AP1000 CONTAINMENT VESSEL EXTERNAL PRESSURE ANALYSIS AND DESIGN

NRC REVIEW PACKAGE

Figure 9.4.7-1 Containment Air Filtration System Piping and Instrumentation Diagram

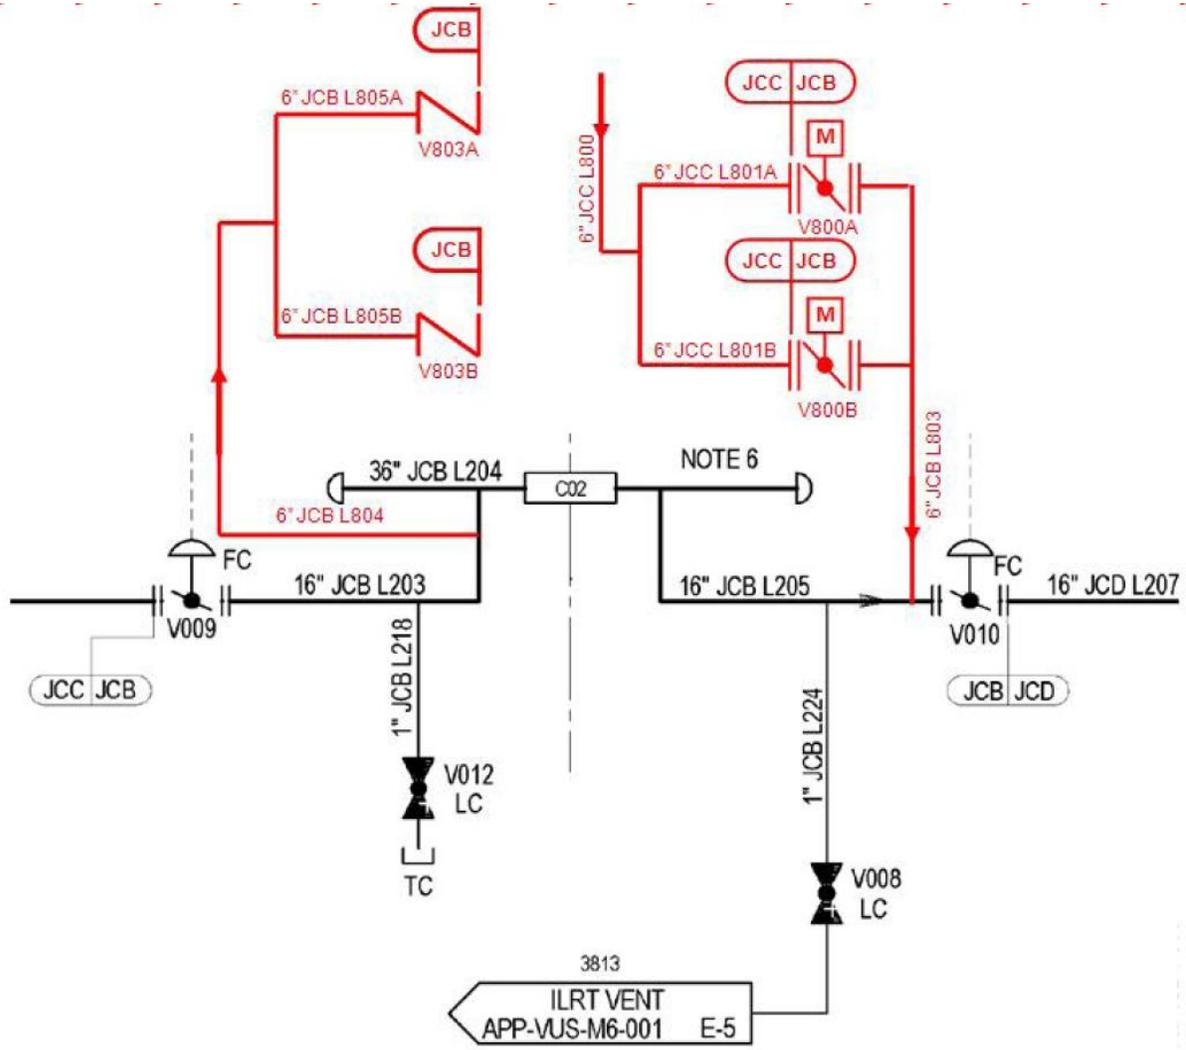
29	Figure 9.4.7-1	Containment Air Filtration System Piping and Instrumentation Diagram	This DCD figure has been revised to include the proposed vacuum relief system.
30	Table 9A-2	Safe Shutdown Components	The motor operated valves (VFS-V800A/B) included in the proposed vacuum relief system are located in Fire Area/Fire Zone 1200 AF 01. Valve VFS-V800A is powered from Division A and valve VFS-V800B is powered from Division C.
31	Tech Spec 3.3.2	ESFAS Actuation Instrumentation	The addition of a vacuum relief subsystem provides design basis protection during a containment overcooling condition to protect the containment vessel integrity. Therefore, a TS is required to identify the OPERABILITY requirements for the accident mitigation functions for this subsystem. Since this system is automatically actuated, TS 3.3.2 requires identifying the actuation signals and their set points.
32	Tech Spec B 3.3.2	ESFAS Actuation Instrumentation	Bases are required for each TS.
